Architectural Review
and Historic Preservation Board
Agenda Report

Meeting Date 2/18/15

File: AR 14-16

RE: Galaxies Restaurant at the North Valley Plaza
801 East Avenue, APN 007-280-063

NORTH ELEVATION 2
PROPOSED EXTERIOR ELEVATIONS

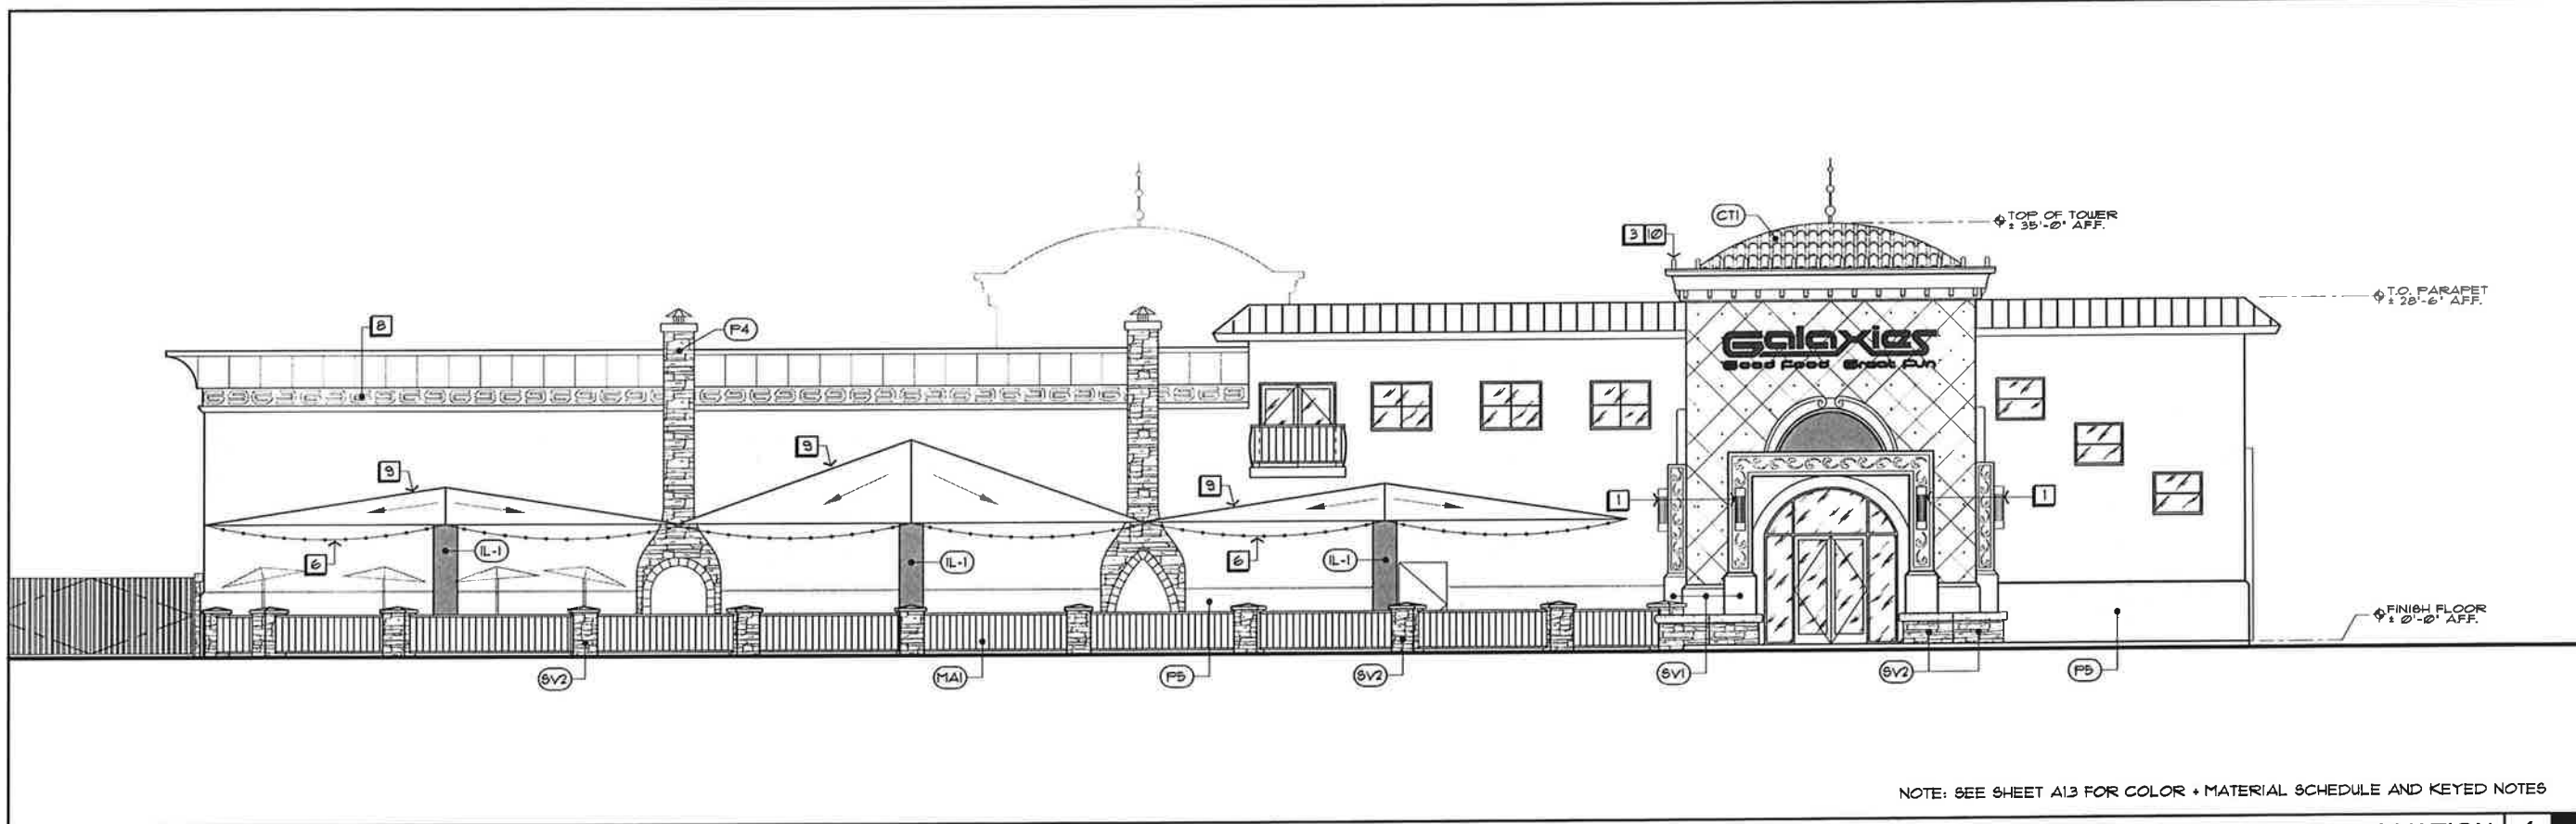
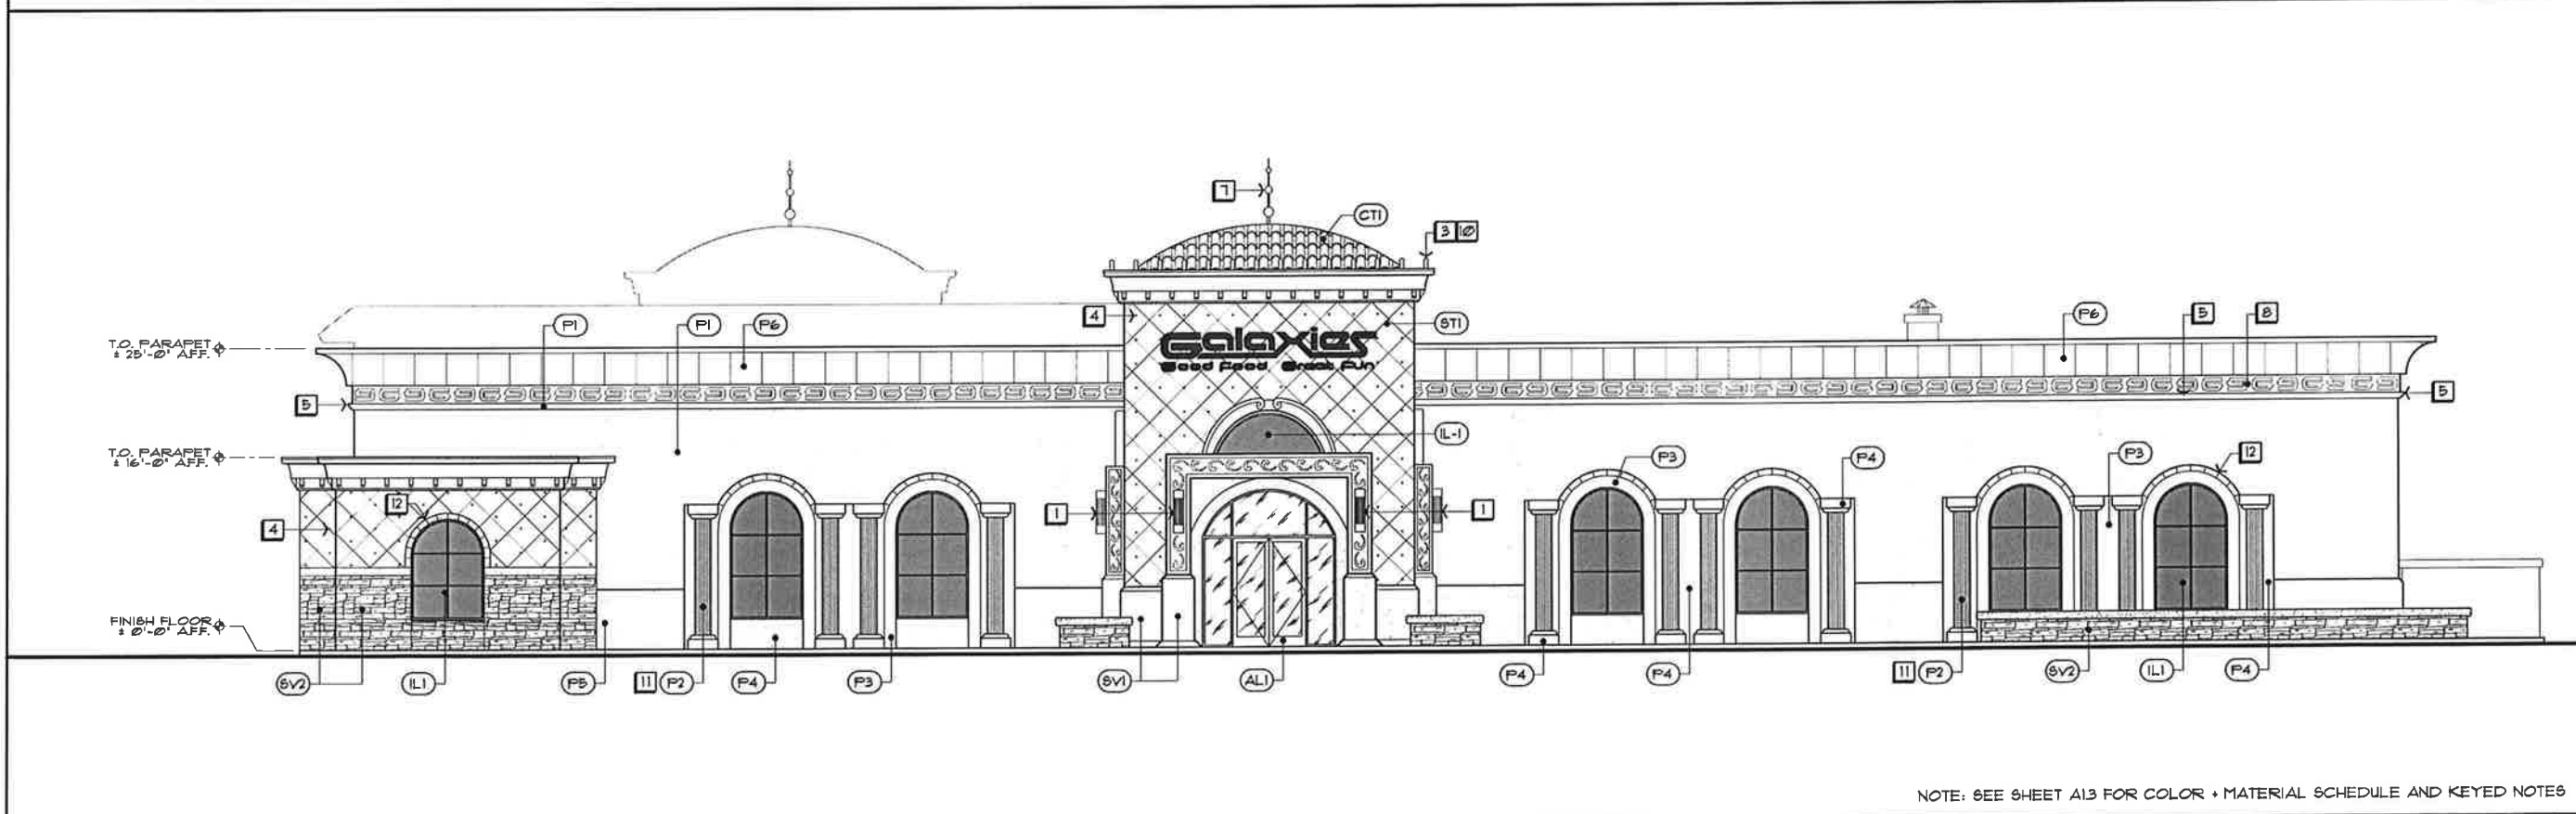
Interest to the otherwise flat walls are created by the faux-windows, and wall-mounted landscape trellises. However, actual fenestration along the walls, rather than only applied ornamentation, would add deeper character. This may be achieved by setting the faux-windows within actual wall-recesses or alcoves with soft overhead down lighting.

The structure contains a series of illuminate wall panels design to appear as windows along the northern elevation. These elements appear to be flat with the wall, while the pilasters on each side would extend approximately 6-inches. To give the walls additional character, and depth staff recommends that the Board discuss with the applicant the ability to recess or provide alcoves to the faux-windows.

1. All approved building plans and permits shall note on the cover sheet that the project shall comply with AR 14-16 (Galaxies). No building permits related to this approval shall be finalized without authorization of Planning staff.
2. All wall-mounted utilities and roof or wall penetrations, including vent stacks, utility boxes, exhaust vents, gas meters and similar equipment, shall be screened by appropriate materials and colors. Adequate screening shall be verified by Planning staff prior to issuance of a certificate of occupancy.
3. All parapet caps and other metal flashing shall be painted, consistent with the approved building colors.
4. The pedestals and other façade elements (arches around windows, wainscot) shall provide additional depth and relief by extending 6 to 18-inches from the structure.

GALAXIES
PRELIMINARY LANDSCAPE PLAN (PAGE 1 OF 2)
PREPARED FOR:
BGE, INC
550 VALLOMBROSA/ PMB 6520
CHICO, CA 95926

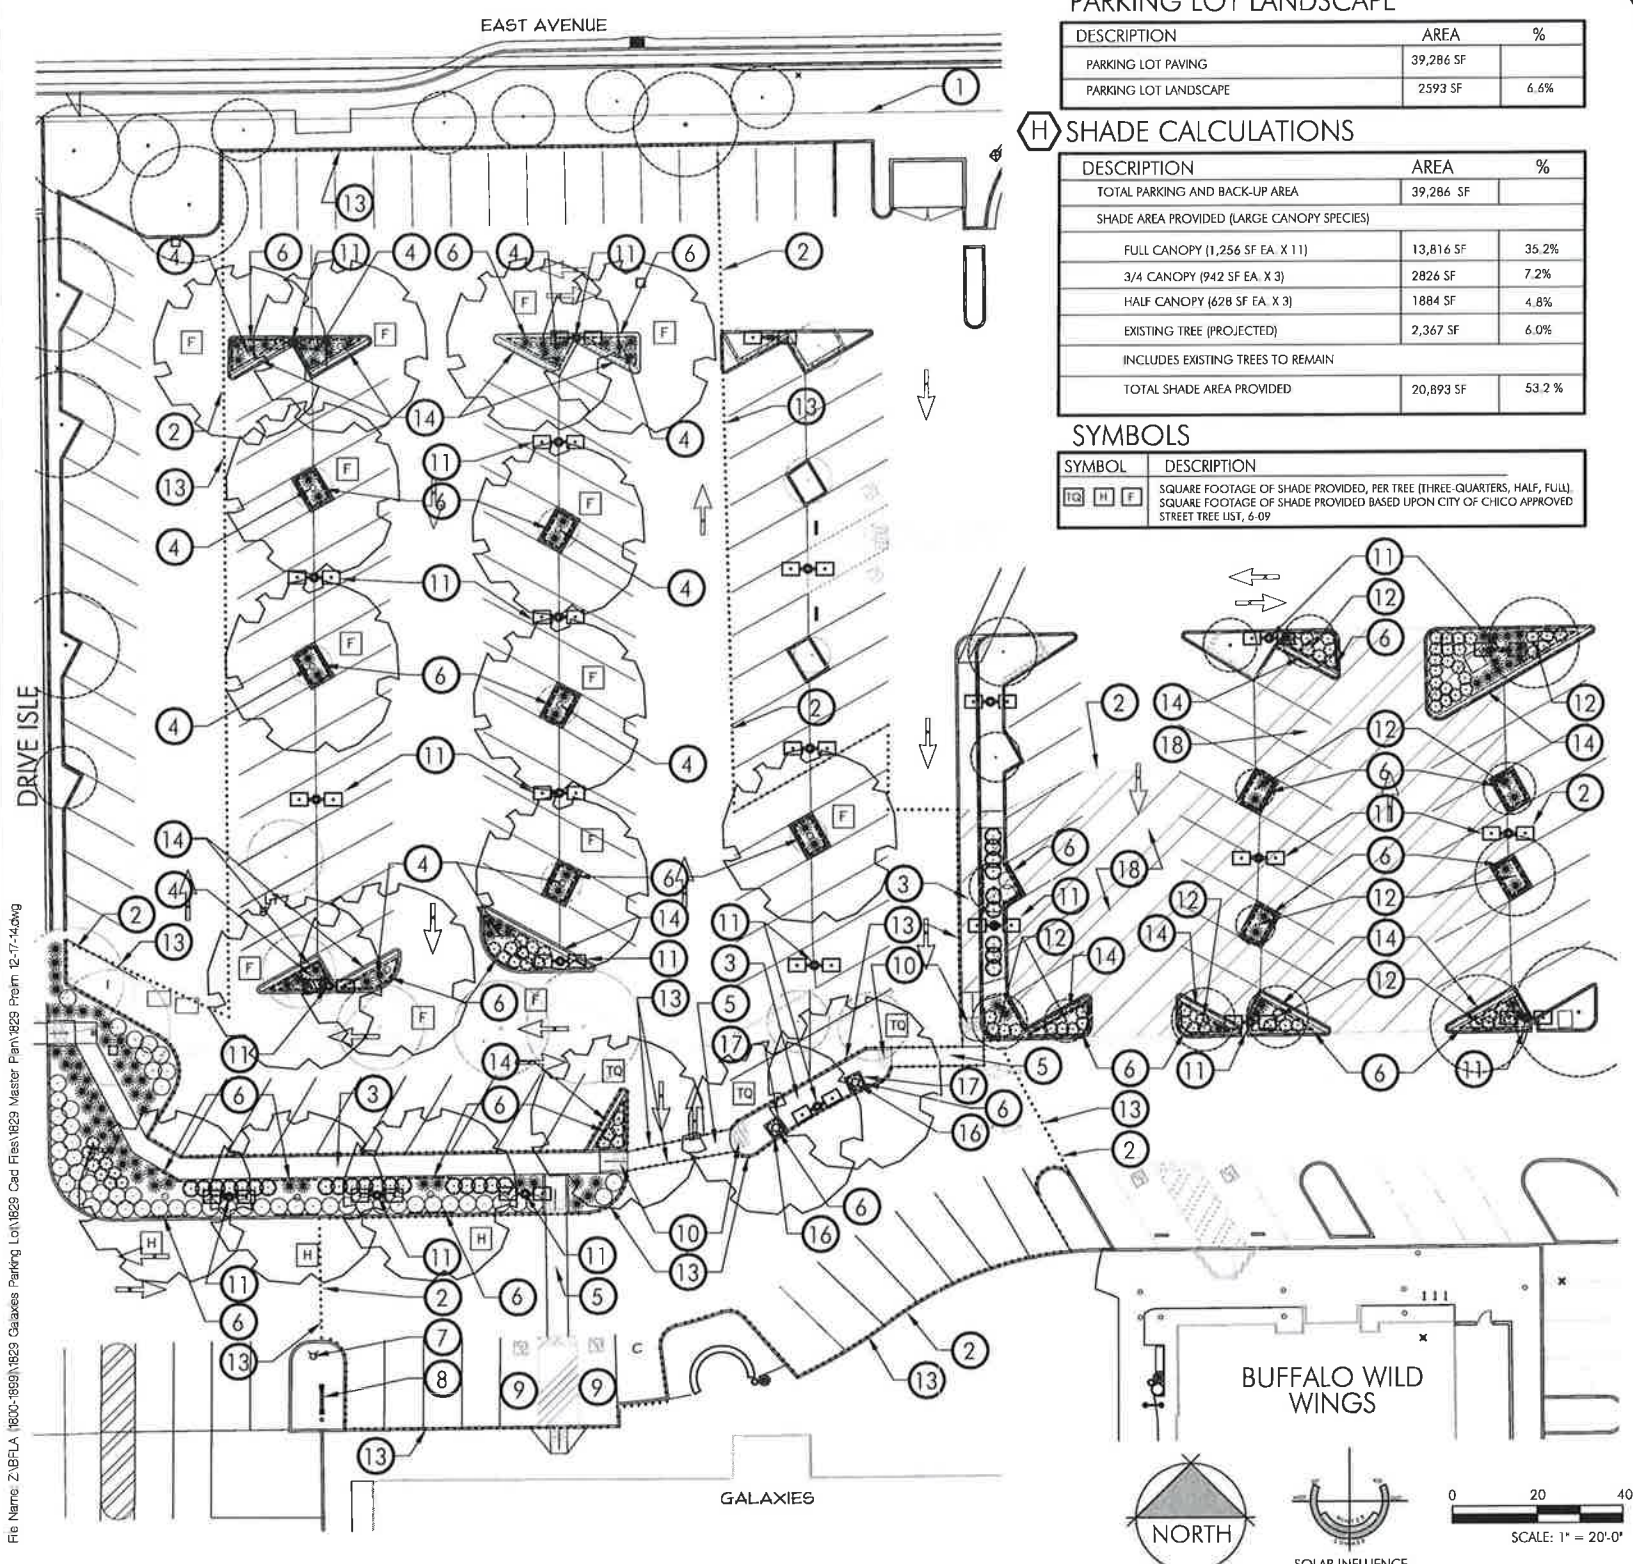
Shade Trees: The applicant is proposing to install silk trees as the parking lot shade tree. Although a beautiful tree, with a variety of color and texture, it is an extremely messy as it drops leaves, seed pods, and flowers at different times of the year. Staff believes that the proposed tree, which is typically fast growing, yet doesn't reach a large height and not noted on the parking lot shade tree list, should be replaced with a new tree(s) that are more suitable for urban development, and does not continually drop litter.

The Landscape Architect has noted to staff that the tree was chosen by the applicant as an extension of design from the building to the parking. Staff wishes that the Board discuss tree alternatives with the applicant and the Landscape Architect and condition the project accordingly.
